# Near-Infrared Tip-Tilt Sensor Preliminary Design Review

KAON 863  
April 25, 2011

# Response to SDR Review Committee Report

# MASS BREAKDOWN

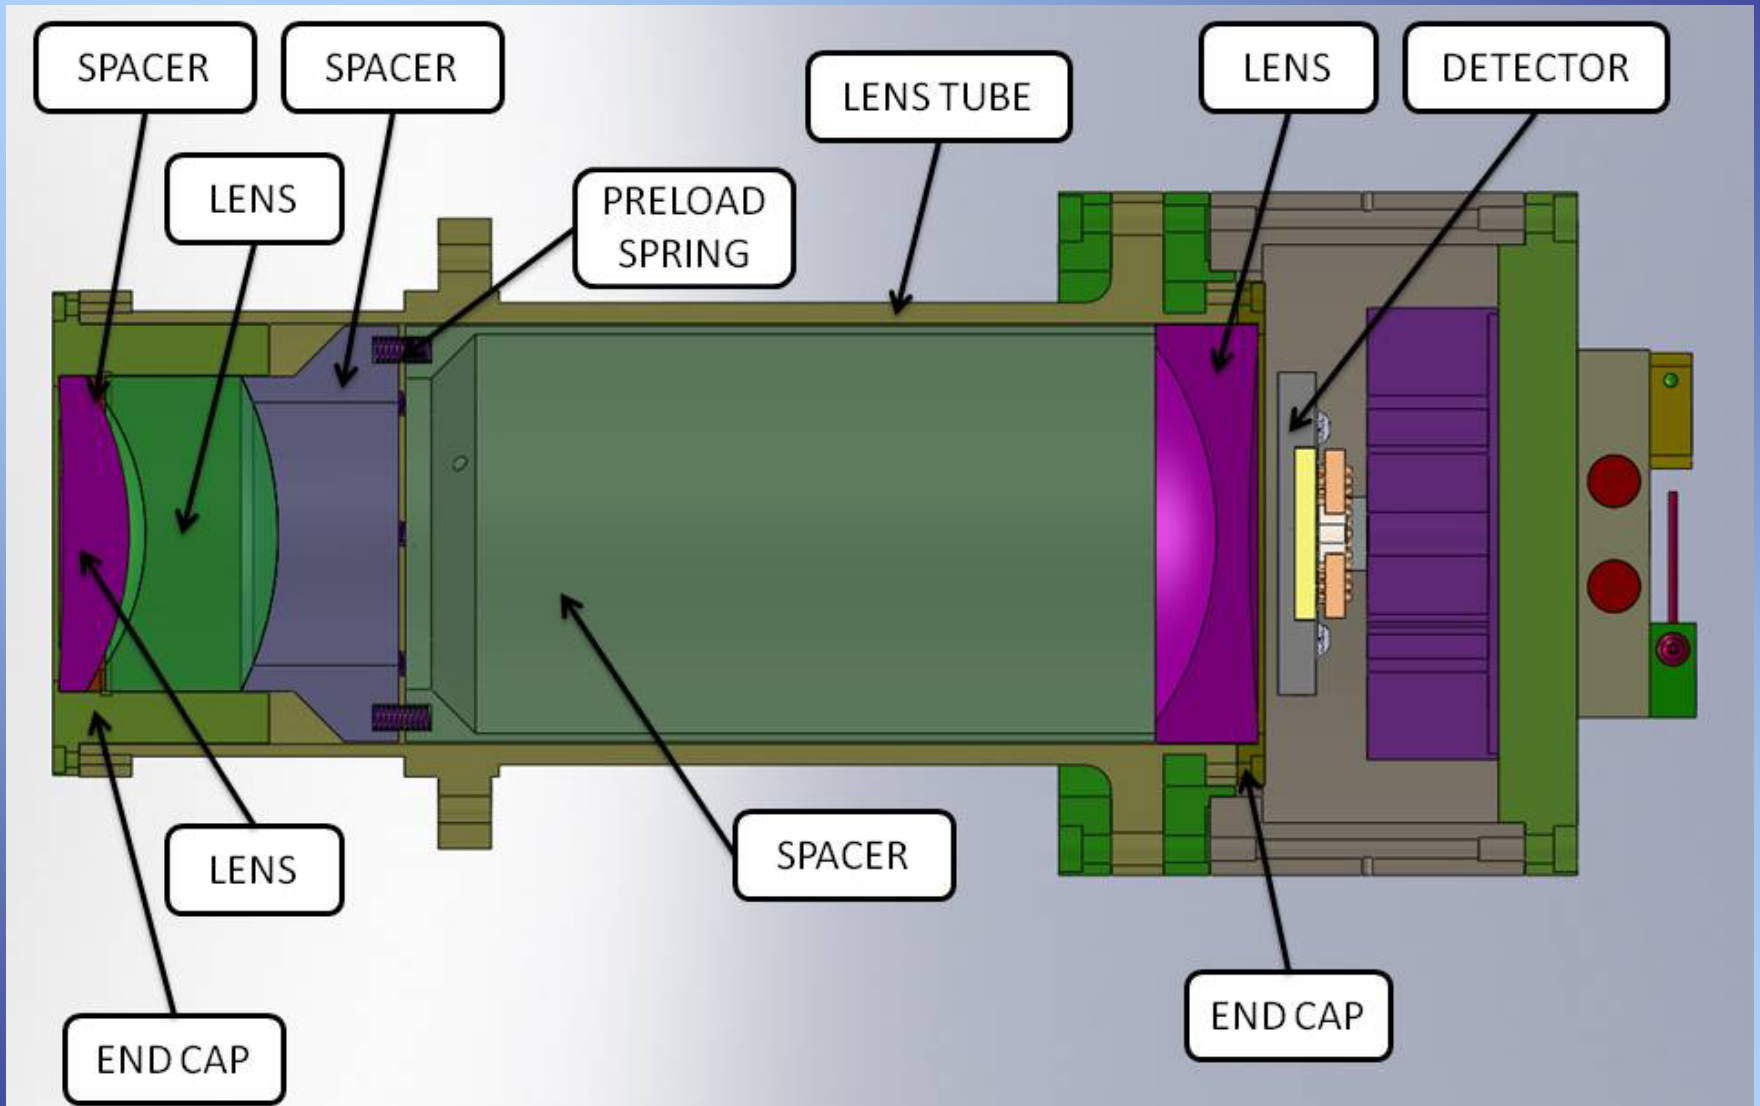
RIQ-CBO3: Is there a plan to do a flexure analysis of the TRICK system during DD and also to check the impacts on AO bench?

- Cryostat and base, no light weighting = 103 lb
- With light weighting = 85 lb
- Analysis in DD phase is planned to determine if cost of light weighting is justified, etc.

current	light-weighted	~ cost
Top cover	9.72 lb	5.26 lb	\$1.5K
Bottom cover	9.37 lb	3.5 lb	\$ 2K
Cold plate	3.5 lb	2.8 lb	\$500
Base	24.5 lb	17.5 lb	\$1.5K

# Filter Pupil Mounting

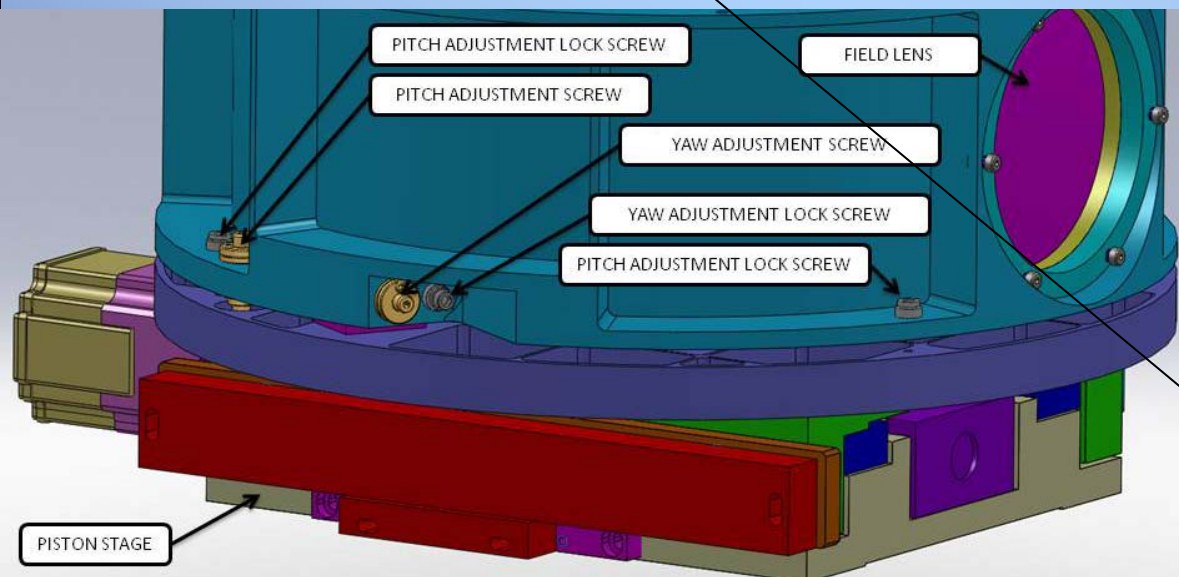
RIQ-RDC6: It's not clear to me how the filters/pupil stops will be mounted? What material will be used. Is there any mechanical design work done yet for the filter holders/pupil masks. I'm concerned about restraining the filters without possible coating damage to the filters.

- Contact made outside optical path.
- Precise pupil stop machined into filter wheel itself, for best repeatability and minimal radial position variation from filter to filter.
- Tangential position errors will be corrected with drive system.

# THERMAL LOAD & COOLING TIME

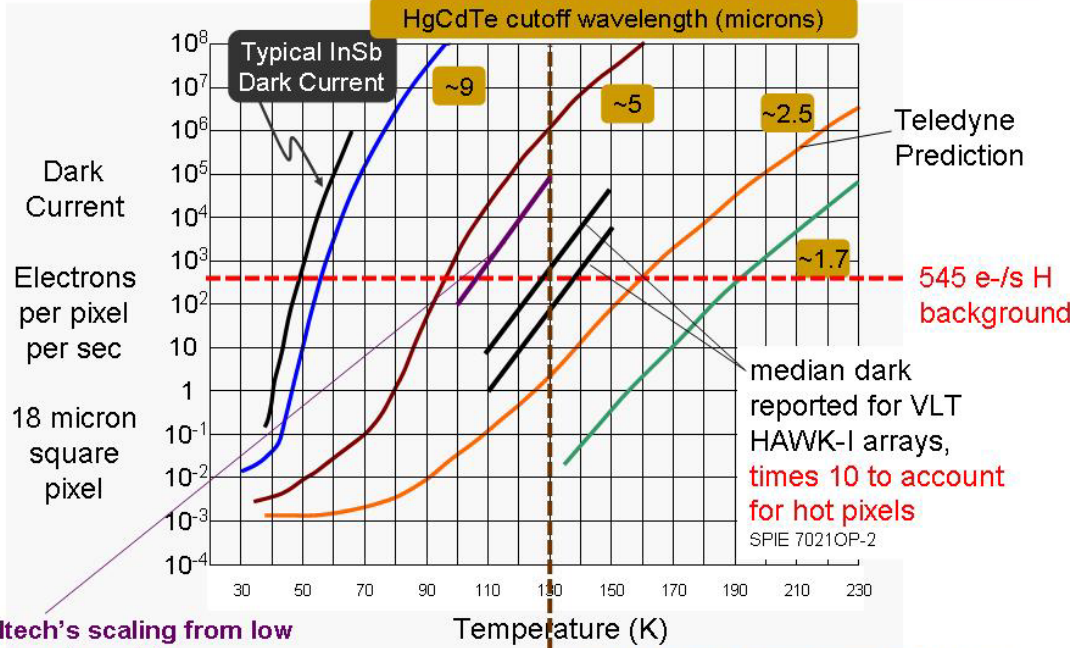
RIQ-BCO3: Have you performed a cool-down analysis and estimated the time for cool-down and warm-up?

- Equilibrium thermal load on cryocooler < 4 W
  - 0.45 m<sup>2</sup> radiation shield : < 2 W
  - 0.0009 m<sup>2</sup> gaps have unit emissivity: 0.02 W
  - Radiation through entrance window: 0.4 W
  - Conduction through G10 Shield support: <0.25 W
  - Conduction through G10 drive shaft: 0.05 W (allocation)
  - Conduction through electrical wires: 0.15 W (allocation)
  - Heater power allowance: 1 W
- Cryotiger with high performance head and PT14 gas: 15 W peak
- Cooling time currently ~36 hr, will be reduced to < 24hr
  - by light-weighting cooled mass from 6.5kg to ~4kg.
  - In DD phase will adapt existing numerical models to provide better estimate: may permit cost saving on low emissivity coatings.
- Warming time = 4 hr: active heating enforces 1K/min slew rate.
  - ~80 W heater power from 2nd servo loop on Lakeshore controller
